9-B-22-HZ

APPLICATION FOR CERTIFICATE OF APPROPRIATENESS

1014 Eleanor St. 37917

Staff Report

A1.5

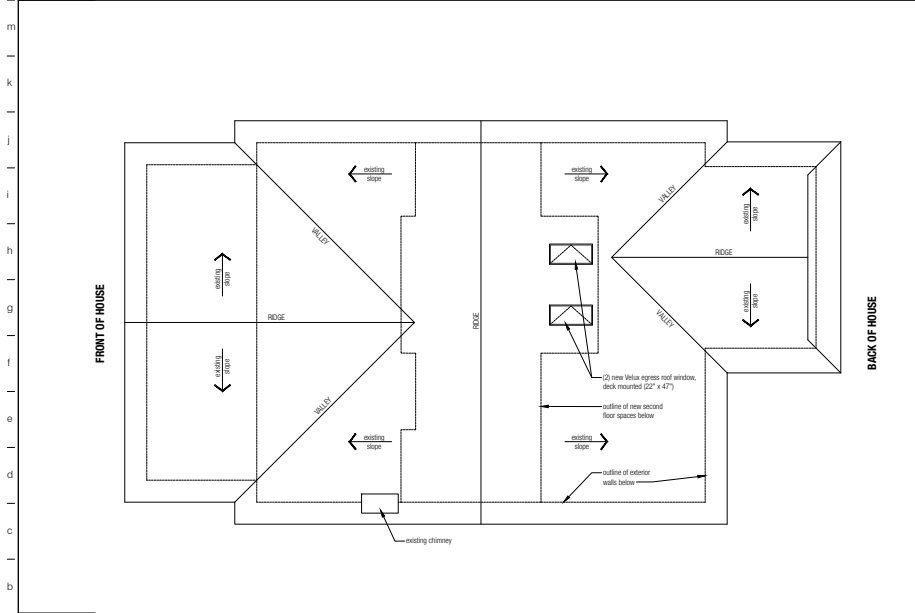
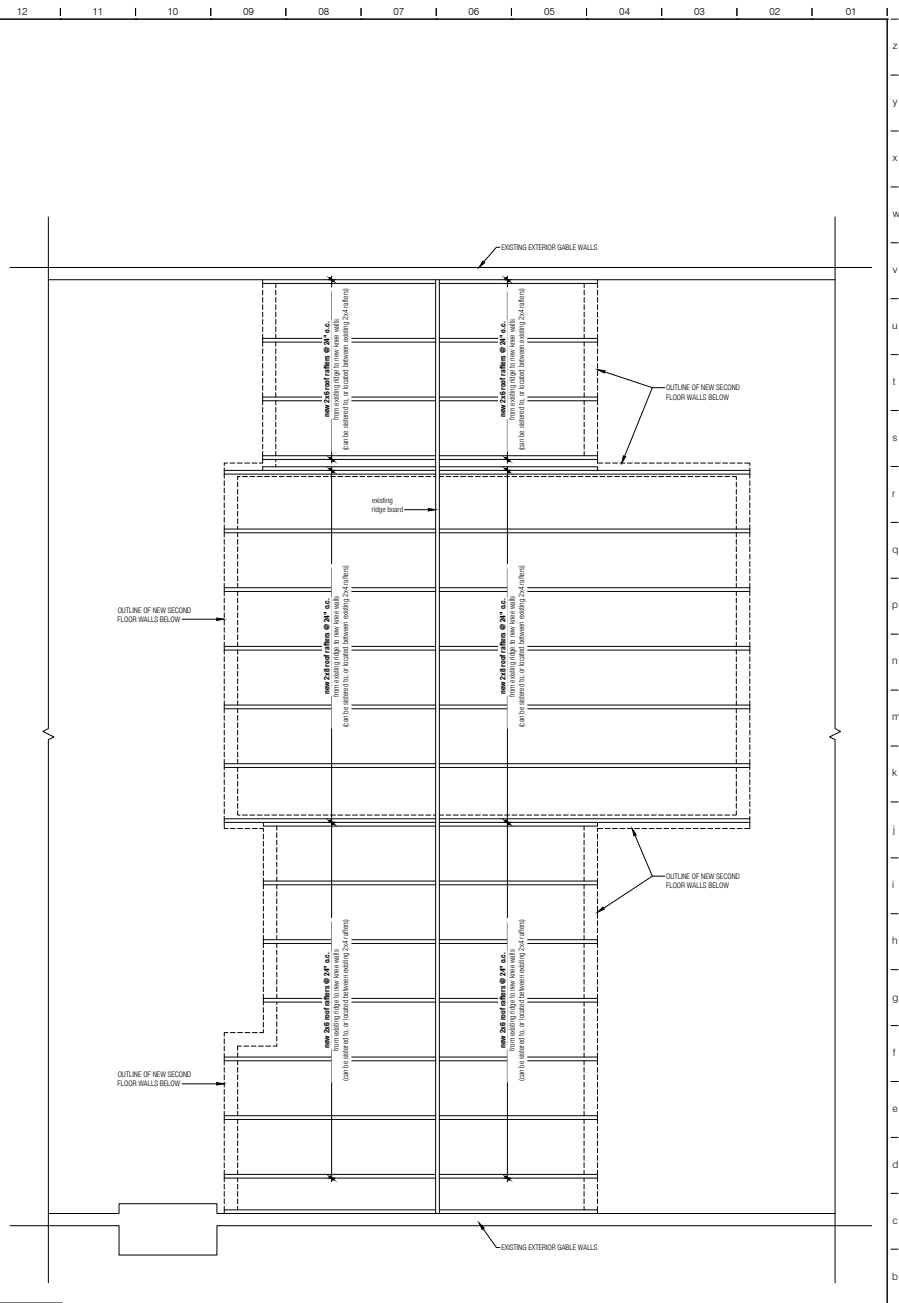
2. The proposed skylight windows do not require removal of historic features or decorative roof elements. They will not be visible from the street. Repair and reconstruction of the original side elevation windows meet the design guidelines.

Staff recommends approval of Certificate 9-B-22-HZ as submitted.
